DEVELOPMENT APPLICATION ASSESSMENT REPORT

ITEM No.	
FILE No.	DA 517/2014/1
ADDRESS	6-8 Cranbrook Road, Bellevue Hill (Drayton House) and Cranbrook Road reserve
SITE AREA	Total site area is 2,381.6m ² including Cranbrook Road reserve (449m ²) which is currently owned by Council.
ZONING	Residential 2(a) and unzoned land (road reserve)
PROPOSAL	Demolition of the existing buildings, removal of trees and the construction of a part three part four storey aged care facility comprising 59 rooms (63 beds) including a roof garden and basement level car parking and storage; new landscaping, fences and siteworks
TYPE OF CONSENT	Integrated development
COST OF INVESTMENT VALUE	\$21,471,650.00
DATE LODGED	28/11/2014 – Original proposal 21/01/2015 – Amended proposal 05/03/2015 – Amended proposal 02/04/2015 – Amended proposal
APPLICANT	Cranbrook Properties Pty Ltd
OWNER	Cranbrook Properties Pty Ltd and Woollahra Municipal Council
AUTHOR	Ms S Richards
TEAM LEADER	Mr D Waghorn

CONSENT AUTHORITY	Joint Regional Planning Panel (JRPP)

SECTION 2- PARTIAL SECTION

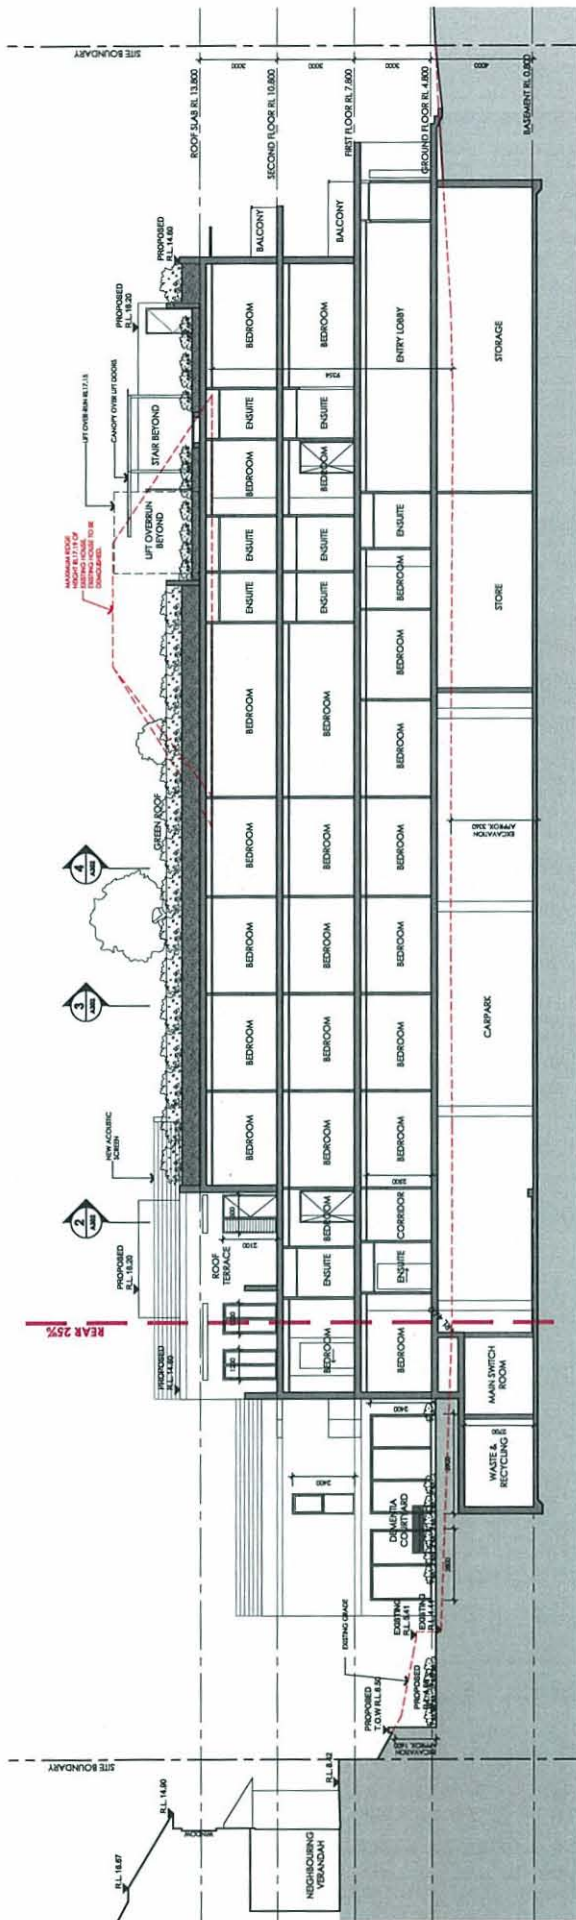
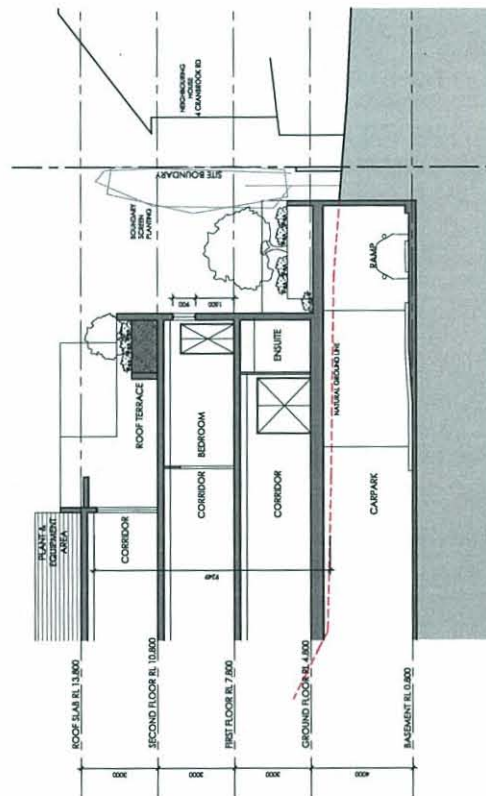
Additional cross sections were provided through the ground floor level rooms in the south-western corner as requested by Council's Urban Design Officer to demonstrate that solar access will be achieved to these rooms (refer to drawing no A302 Rev 03 dated 5/3/2015).

The proposed development fails to provide reasonable daylight and sunlight to rooms on the "ground level" in the south-west corner of the site. These rooms are between 4.5m and 8.5m below the level of Cranbrook Road, which is 8m away. These rooms will receive very limited sun and poor daylight.

1 RETAINING WALL MOVED 0.5m AWAY FROM BUILDING.
